FINAL ALTERNATIVES ASSESSMENT
FOR OTHER CONTAMINATION SOURCES
INTERIM RESPONSE ACTION
RAIL CLASSIFICATION YARD, RMA

October 1989

RESPONSES TO EPA COMMENTS ON THE ALTERNATIVE ASSESSMENT
FOR OTHER CONTAMINATION SOURCES, INTERIM RESPONSE ACTION
FOR THE RAIL CLASSIFICATION YARD, DRAFT FINAL REPORT

Figure: A-8

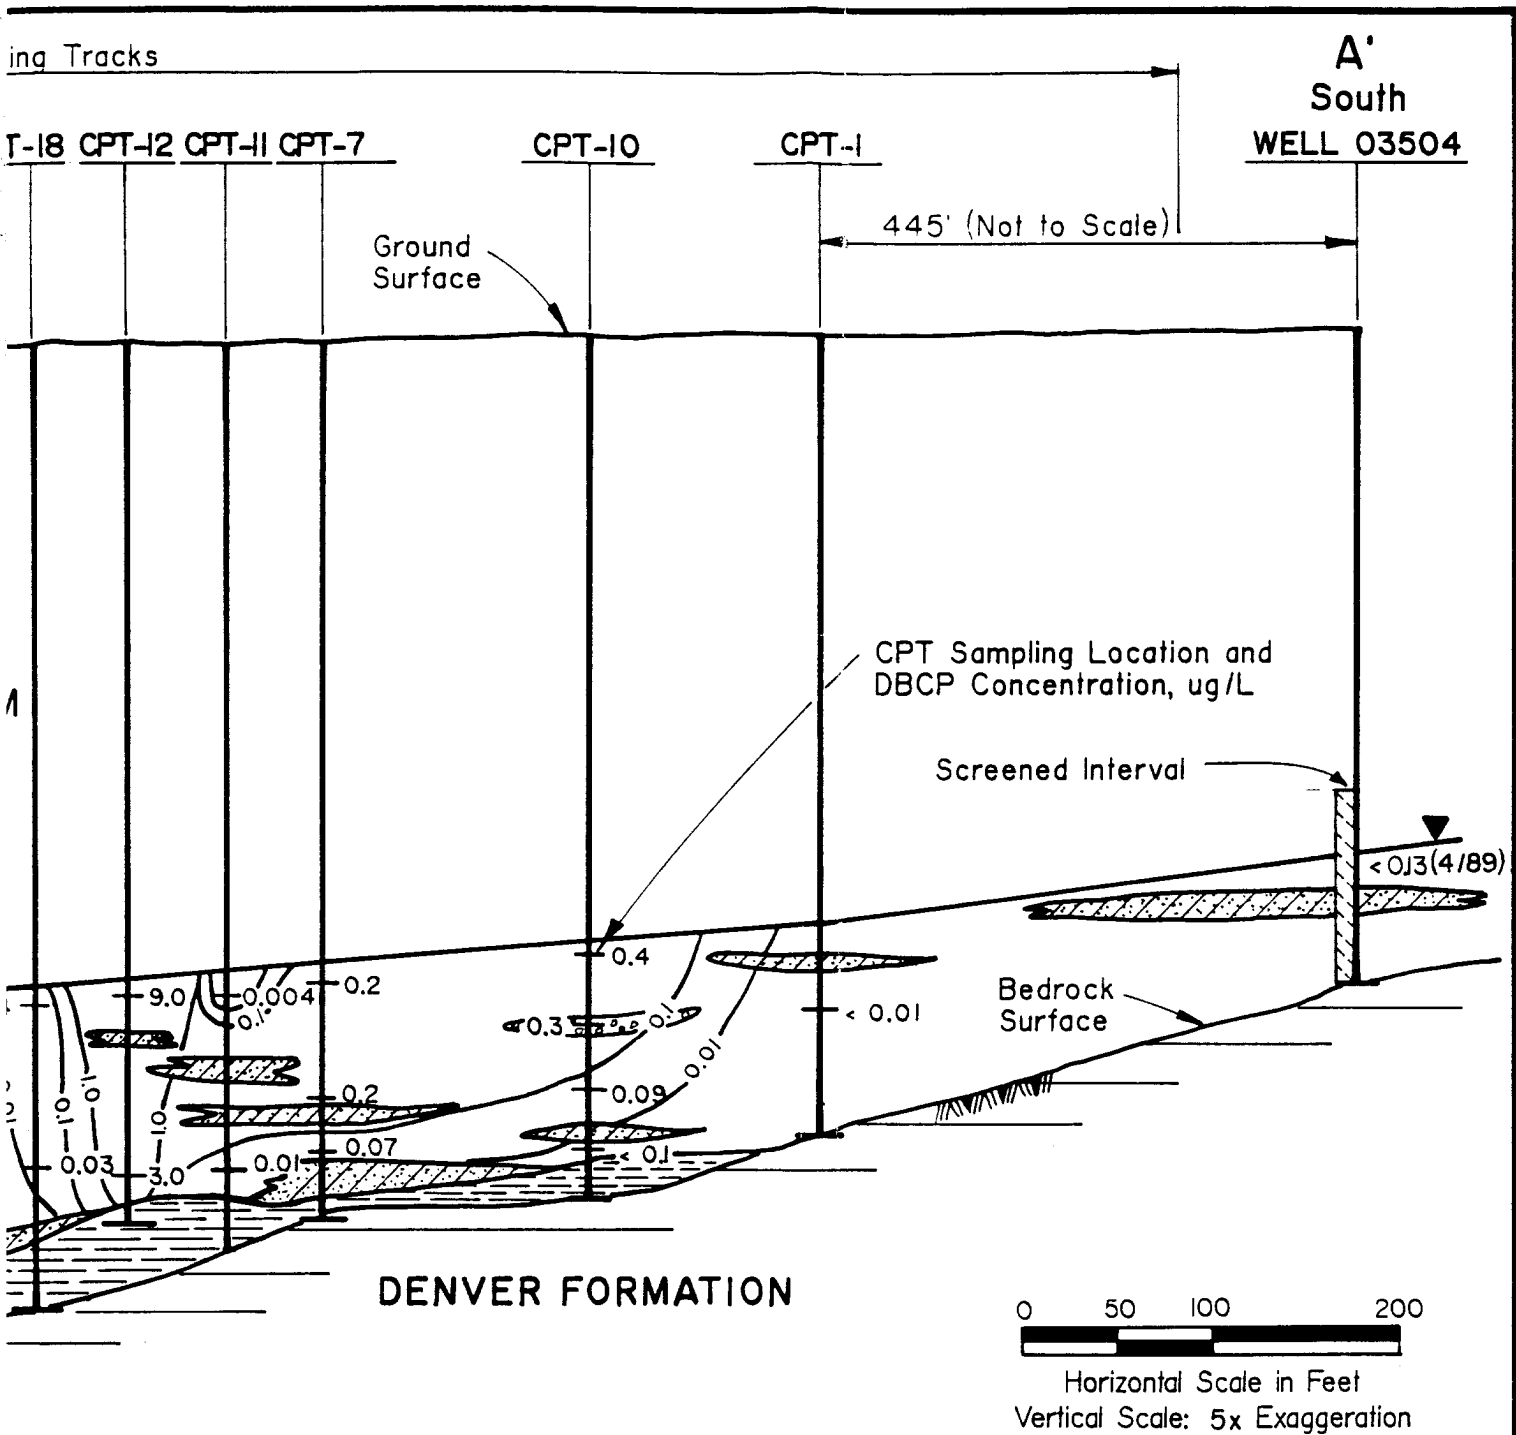
Page 9, Section 4.4, second paragraph, please expand the text to explain the statements that the concentration of DBCP in groundwater consistently decreases with depth. Please expand the basis for this statement and the assessment made to confirm this statement.

Section 4.0 of the Alternative Assessment Document is a summary of the railyard site characterization. A more detailed description of the results of the site investigation is included as Appendix A. Within Appendix A, groundwater quality and vertical distribution of DBCP in the alluvial aquifer are discussed in Section 2.3, beginning on Page A-10. The groundwater quality data are listed in Tables A-3 and A-4, and the vertical distribution of DBCP is illustrated in Figures A-8 and A-9.

Groundwater samples were collected from more than one depth in eleven of the CPT borings in order to investigate the vertical distribution of DBCP. Typically, one sample was collected from the upper two feet of the saturated zone, and one was collected from the lowermost permeable zone above the Denver Formation bedrock. The DBCP concentration decreased with depth in the aquifer in eight of the eleven CPT locations and in the 2-well cluster (Wells 03502 and 03503) located within the plume.
